FLEX General Notes

MODIFYING THE MP-A PROCESSOR BOARD FOR FLEX 2.0

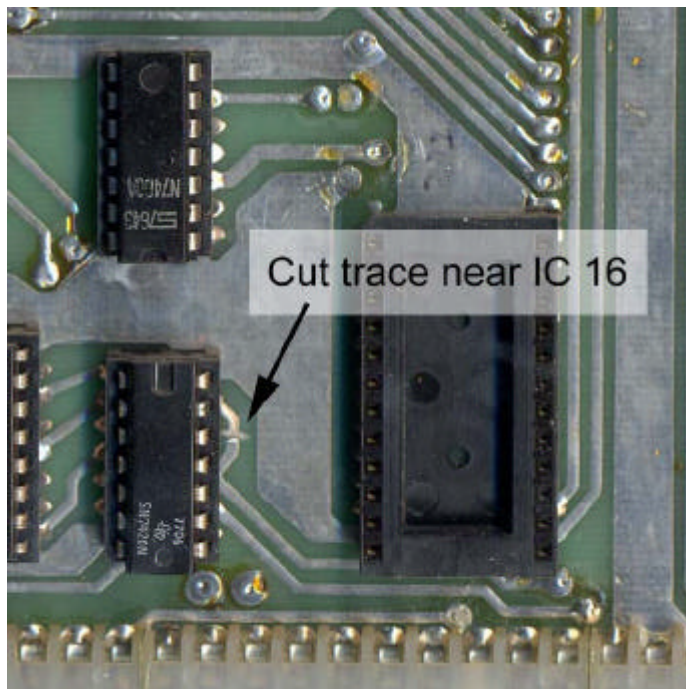
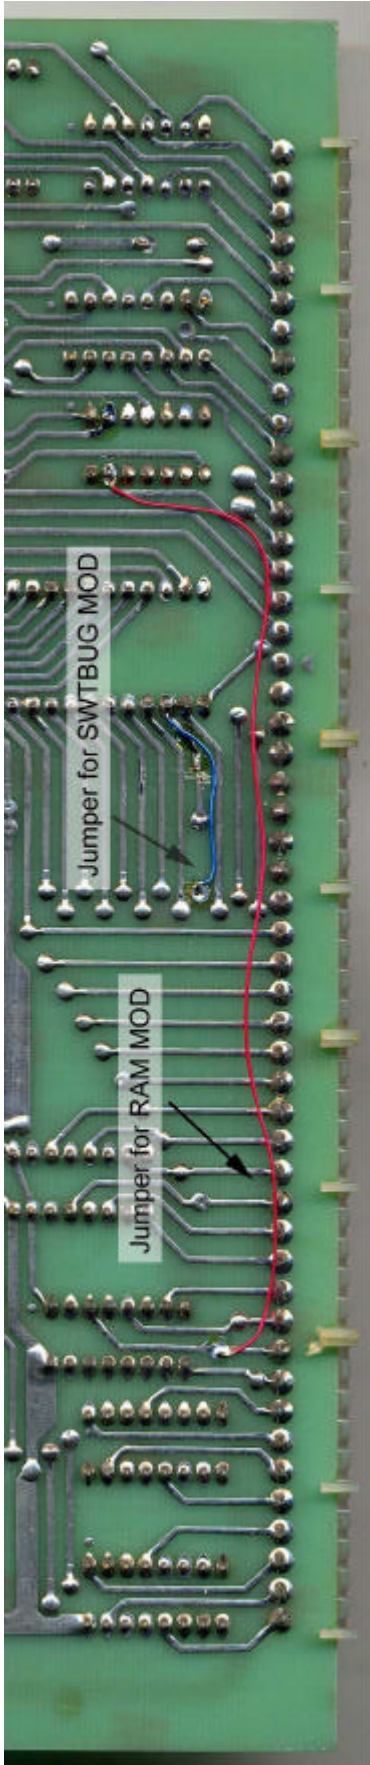
1)   Cut the foil trace connecting pin 10 to pin 13 of IC16 on the "TOP" side of the board. IC16 is a 7420 and is the third IC from the left on the bottom row as viewed from the "TOP" side.

2)   Solder an insulated jumper from the now unconnected pin 13 of IC16 to pin 3 of IC7 on the "BOTTOM" side of the board. IC7 is a DM8097 or a 74367 and is the third IC from the right on the bottom row as viewed from the "TOP" side.

3)   If you have put IC3 (the 6810 RAM chip) in a socket, simply unplug it. If it is soldered in place, it will be easier to disable it by cutting the foil trace connecting to pin 13 of IC3 on the "BOTTOM" side of the board. Next solder a jumper between pins 12 and 13 of IC3.

Cut trace near IC 16

Jumper for SWTBUG MOD

Jumper for RAM MOD
